MEMORANDUM

From:	Tina Cuss Ecology Officer		
Service	WBC Ecology	App No:	260446
Address:	95 Butts Hill Road, Woodley, Wokingham, RG5 4NT.		
Proposal:	Householder application for the proposed erection of a first floor side and part single part two storey rear extension.		
Type of Development:	Other Householder		
Site Visit Made:	No

Figure 3 - Proposed elevations showing how the features with potential to host roosting bats will be unaffected by the works

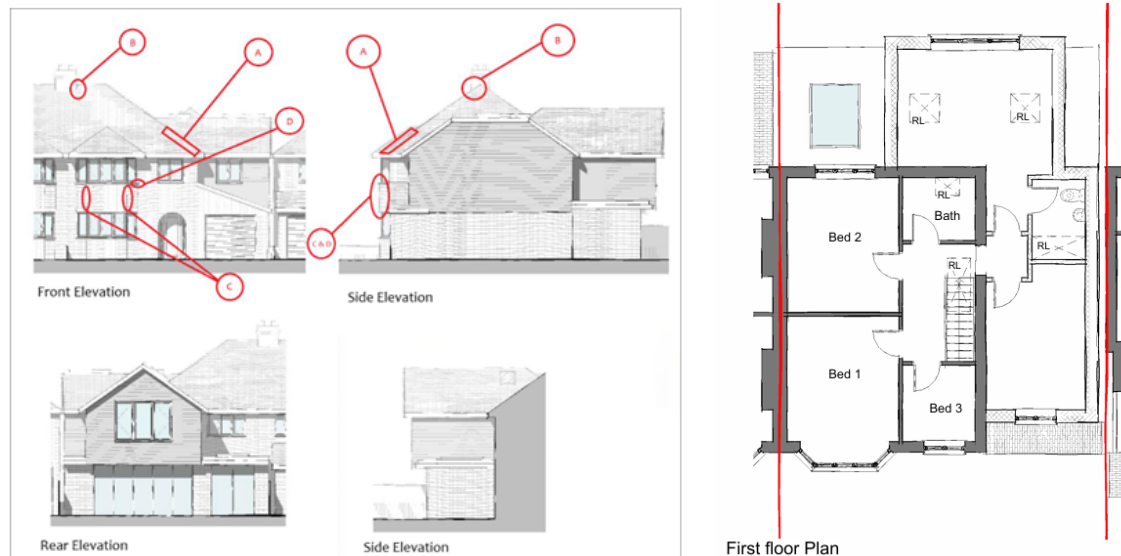
If there are any changes or works to or which affect the front hanging tiles or proposals to clad the front elevation further bat surveys needed and mitigation strategy must be submitted to and approved by the LPA as well as a copy of any European Protected Species Licence needed for the works to undertaken legally.

I note the Ecologist has not assessed the revised plans and elevations that include rooflights in the side and rear extensions, as well as the side extension flat roof. Confirmation is needed from the Ecologist that the addition of rooflights in the bathroom ceiling will not introduce any light in main loft void cavity roost around the retained chimney or affect any roosts accessible via PRA Feature A (Gaps between tiles below south western roof hip).
